# Product Change Notification

<b>Date Issued :</b>	August 18, 2023	<b>PCN Number :</b>	514062
<b>Reason for Change :</b>	Change to Product		
<b>Description of Change :</b>	Molex is introducing a slight geometry change (relief slot) to the MX150 product family to eliminate the need for moisture conditioning the connector housing prior to the finished goods assembly process.		
<b>Reason for Short Notice :</b>	Special Request		
<b>Assessment of Change :</b>	Dimension analysis		
<b>Planned Implementation Date :</b>	April 04, 2024		
<b>Sample Availability Date:</b>	November 03, 2023		
<b>Internal Molex Qualification Date :</b>	November 10, 2023		
<b>Last date to request Samples by Customer :</b>	September 15, 2023		
<b>Traceability Code Markings / Date :</b>	No special marking on the product or packaging

## Change Overview

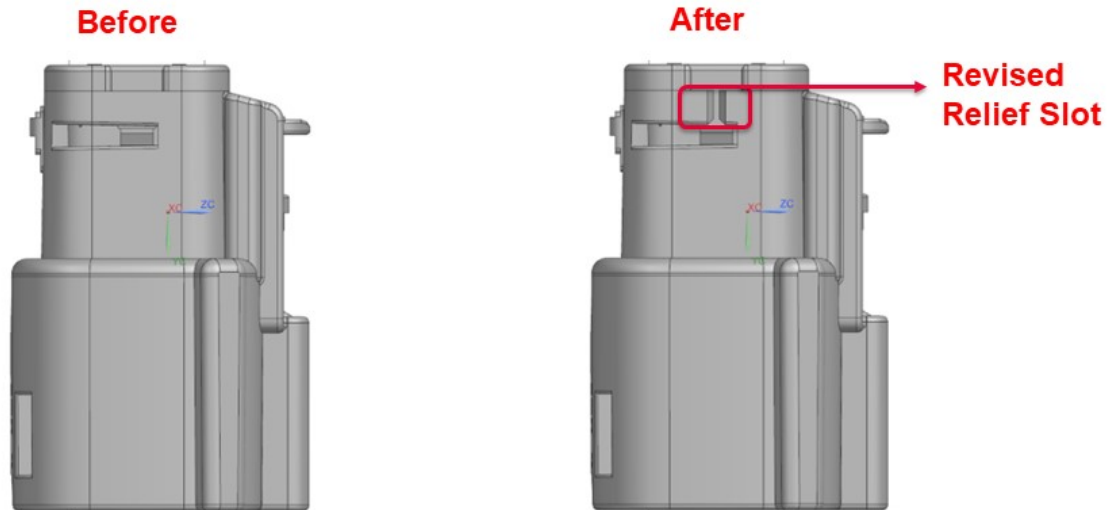
- Molex is introducing a slight geometry change (relief slot) to the MX150 product family to eliminate the need for moisture conditioning the connector housing prior to the finished goods assembly process. Refer to existing and revised housing geometry shown.

- The existing connector housing design requires moisture conditioning to avoid damage during the assembly process. The revised design is a permanent change that eliminates the potential damage and the need for moisture conditioning.

- There is no impact to part fit or function. There is a visual difference between the existing and revised connector housing where plastic has been removed for the relief slot.
